### **Amendment to the Drawings**

Attachment: Figures 1-8 (including Amended Figures 1-6 and 8)

Marked-up copy showing changes to Figures 1-6 and 8

FIG. 1

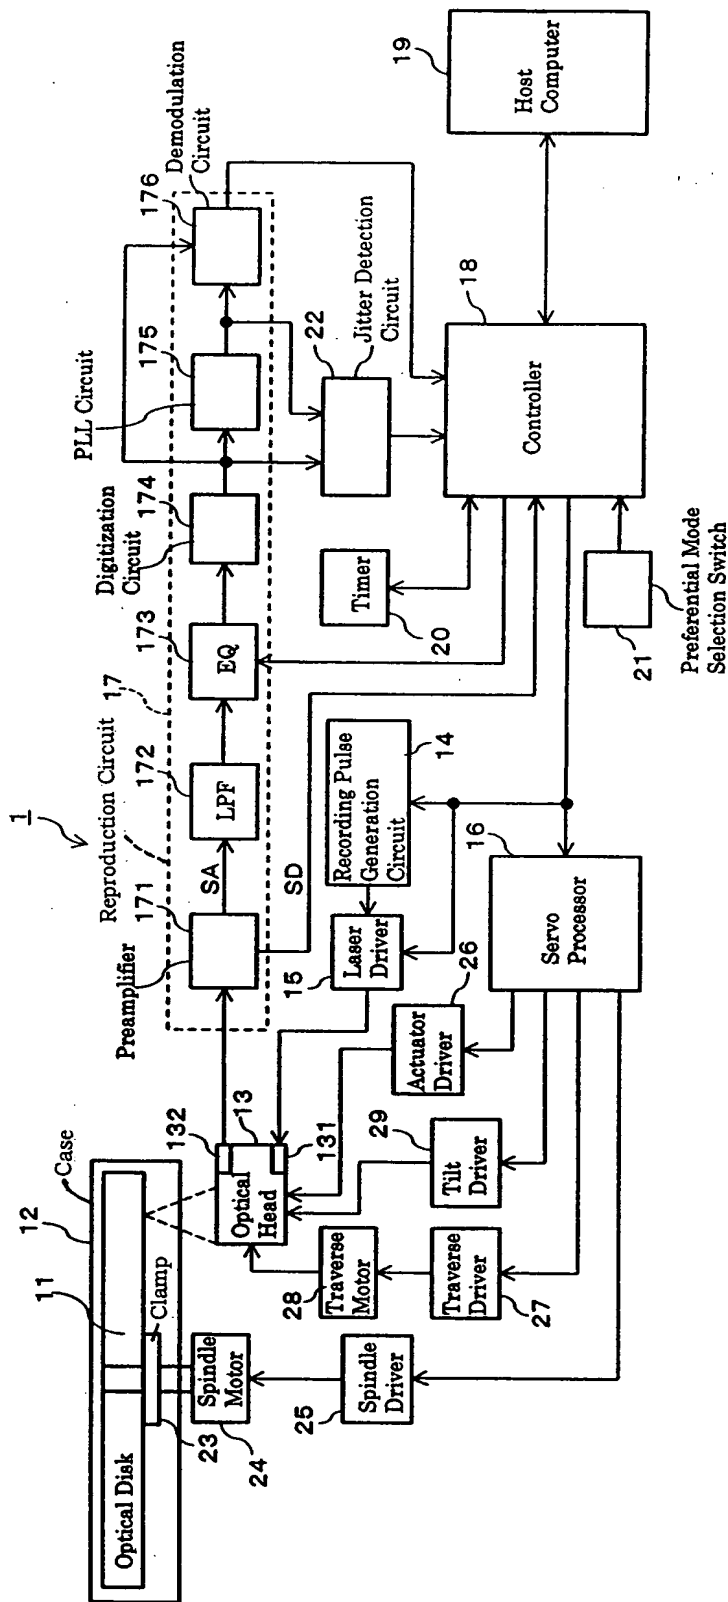
Figures 1 and 5 were amended by the previous amendment to label the circuit blocks. By this amendment, blocks 12, 17, and 23 are labeled as "case", "reproduction circuit", and "clamp", respectively.

FIG. 2

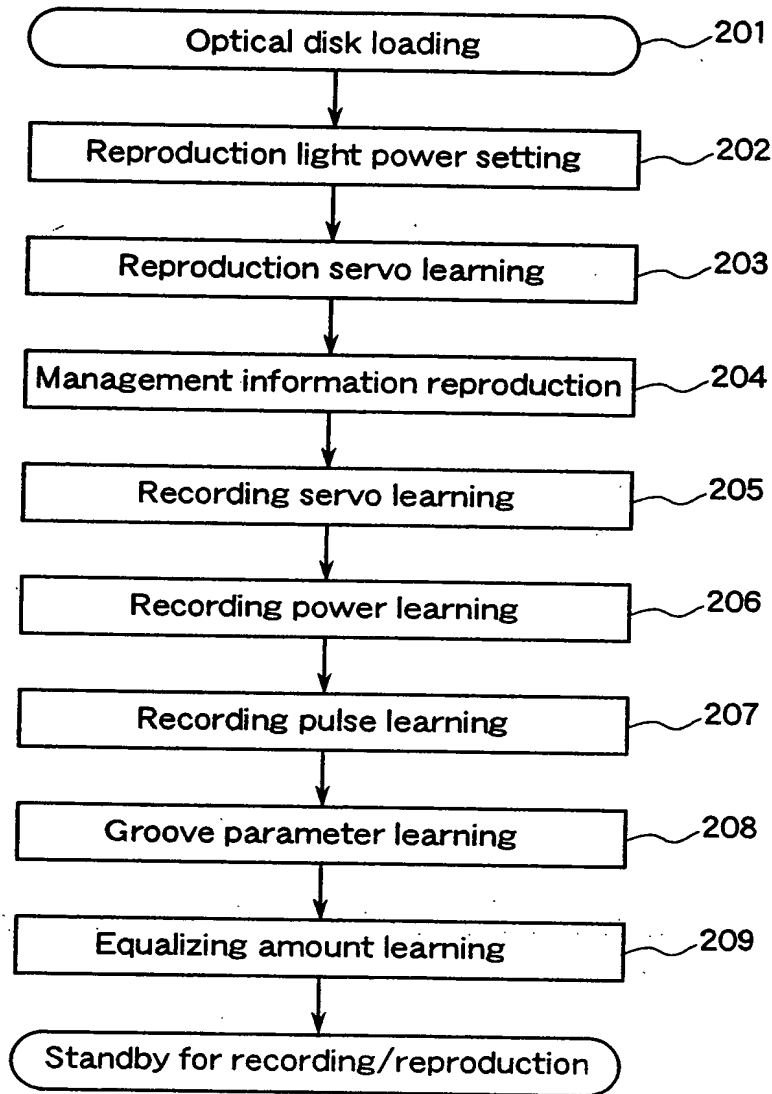
Figures 2-6 and 8 are amended to include English words.
